**NORTH AMERICAN—REINFORCEMENT OF HORIZONTAL STABILIZER  
AND FIN—P-51B, P-51C, AND P-51D**

**NORTH AMERICAN—REINFORCEMENT OF HORIZONTAL STABILIZER  
AND FIN—P-51B, P-51C, P-51D, AND P-51K**

This Technical Order replaces T. O. No. 01-60J-18, dated 8 April 1944, to include new and additional information indicated by black revision line. The purpose of this revision is to require the use of 1/4-inch rivets in lieu of 3/16-inch rivets to attach the elevator outboard and rudder upper hinge fittings, part No. 73-21008, to the stabilizer ribs, providing additional shear strength to reduce the possibility of shearing these rivets.

**Figure 2 - Horizontal Stabilizer Front Spar Reinforcing Doubler**

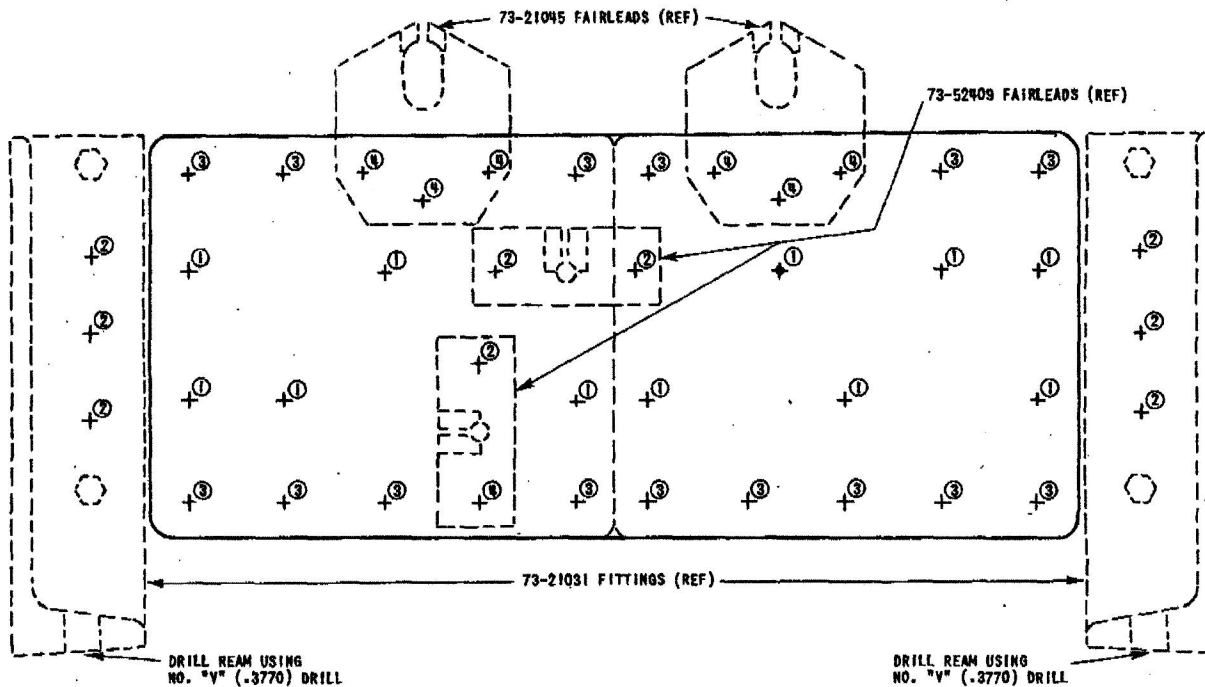
j. Secure the new doubler to the forward side of the front spar using bolts as indicated in figure 2.

l. Secure the four fair-leads to the spar using AN3- bolts as indicated in figure 2. Install bolts so that nuts are on aft side of spar.

m. Locate a point 1/2 inch below the left-hand fair-lead, part No. 73-21045, on the fair-lead center line, and drill a No. 12 (.189-inch) hole through the doubler and spar. (See figure 2.) Install bolt and secure with nut on aft side of spar and washer under bolt head.

n. Remove three rivets securing each fitting, part No. 73-21031, to the front spar. (See figures 1 and 2.) Drill ream the holes using a No. 12 (.189-inch) drill and install one AN3- bolt in each hole. Install bolts so that nuts are on aft side of spar and washer is under bolt head.

Figure 4 - Station 70 1/2 Horizontal Stabilizer Rib Reinforcing Doubler Channel

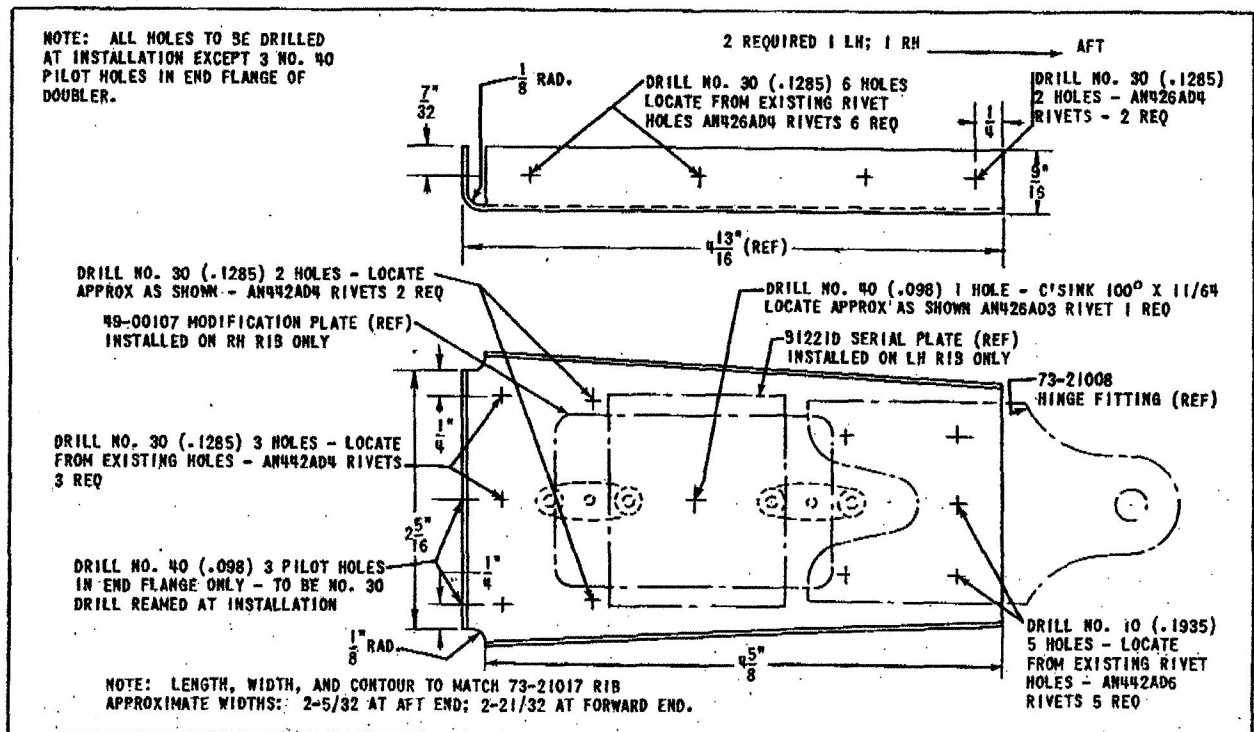
(9) Drill five size D (.246-inch) holes in the aft end of the doubler to match the holes provided in the rib web for the hinge fitting, part No. 73-21008. Drill the holes in the rib web and hinge fitting to the same size. Ream the holes using a .250-inch reamer.

(10) Select five rivets, part No. AN442AD8-10, to give a tight fit when inserted in the five reamed holes. Attach the hinge fitting, part No. 73-21008, to the rib and doubler using the rivets selected.

**NOTE** The webs should be riveted together in at least three places as indicated in figure 4. Additional rivets will be required if the rib web has been cracked; these should be located as necessary to properly reinforce the rib web.

Figure 5 - Station 61 1/2 Fin Rib Reinforcing Doubler Channel

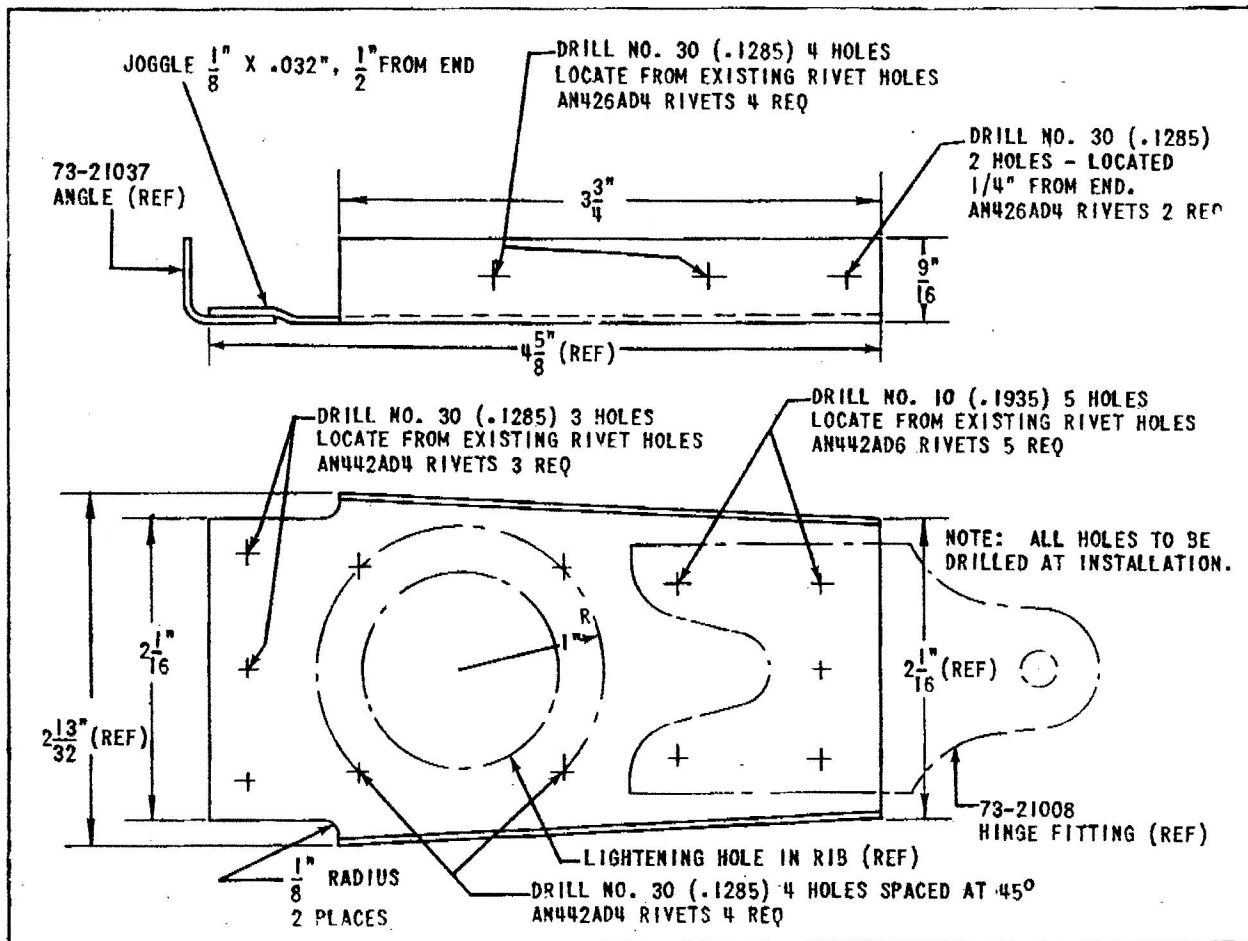
(8) Drill five size D (.246-inch) holes in the aft end of the doubler to match the holes provided in the rib for the hinge fitting, part No. 73-21008. Drill the holes in the rib web and hinge fitting to the same size. Ream the holes using a .250-inch reamer.

(9) Select five rivets, part No. AN442AD8-10, to give a tight fit when inserted in the five reamed holes. Attach the hinge fitting, part No. 73-21008, to the rib using the rivets selected.
